Remarks

In the drawings:

FIG 6

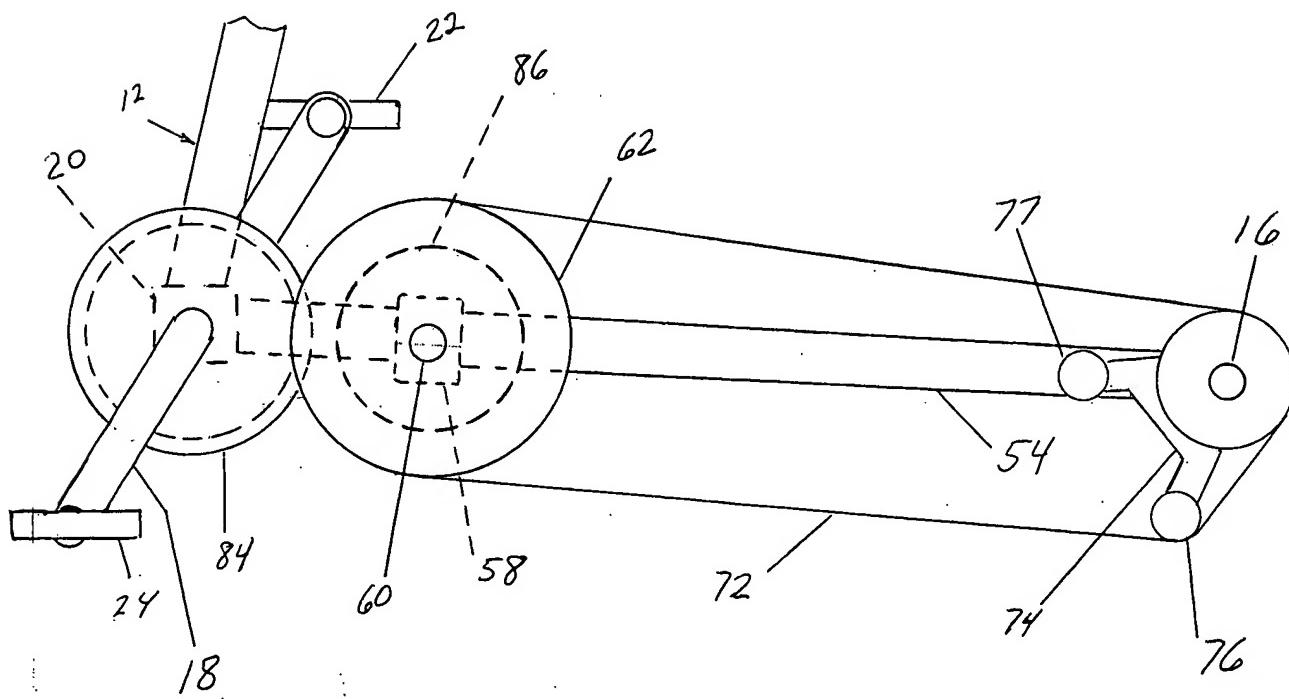
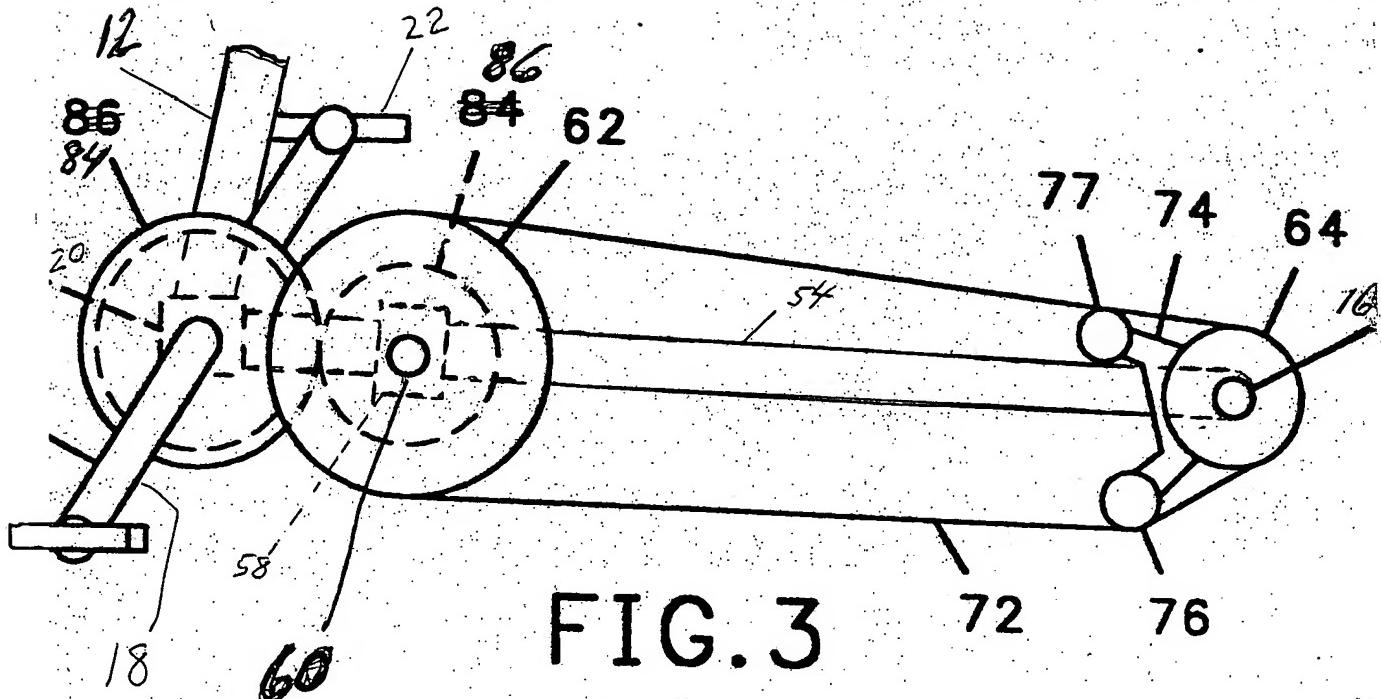
indicia numbers 86 and 84 were exchanged on Figs. 2 and 3. The examiner also requested a new drawing to show the sliding action of the assembly 58. To show this, frame member 54 was added to Fig. 3 and new Fig. 6 was added. Fig. 3 shows the slide assembly 58 with the gears 84, 86 engaged to each other and new Fig. 6 shows the slide assembly with the gears 84, 86 disengaged from each other. It is believed with these amendments that the objections to the drawings have been overcome. The applicant believes that all the elements shown in new Fig. 6 have been clearly set forth in the specification such that the addition of new Fig. 6 does not constitute new matter.

Please amend the drawings as set forth in the attached pages. Amendments to Figs. 2 and 3 are shown in the attached pages in red, and new Fig. 6 is added on a separate page. Formal copies of the replacement pages of drawings and new Fig. 6 are attached as separate documents.

FIG. 2

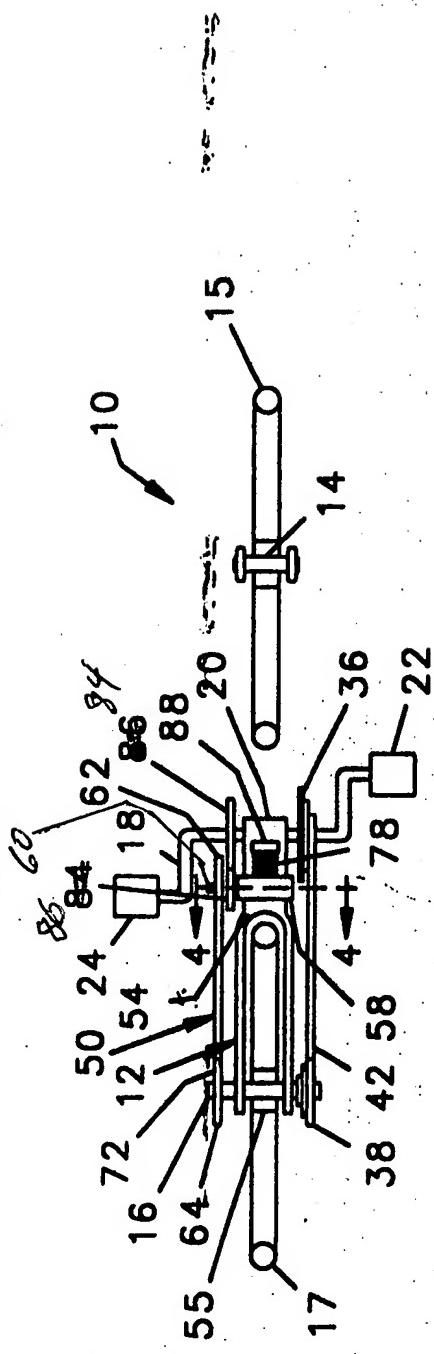
The applicant has submitted herewith amendments to Figs. 2 and 3 of the drawings and a new Fig. 6 intended to overcome the examiner's rejection thereto under 37 CFR 1.83(a). Among the objections, the examiner stated that the elements shown in Figs. 2 and 3 were not as stated on page 6 of the text. Namely, the "second gear 86 does not rotate with the first sprocket 62." To overcome this conflict,
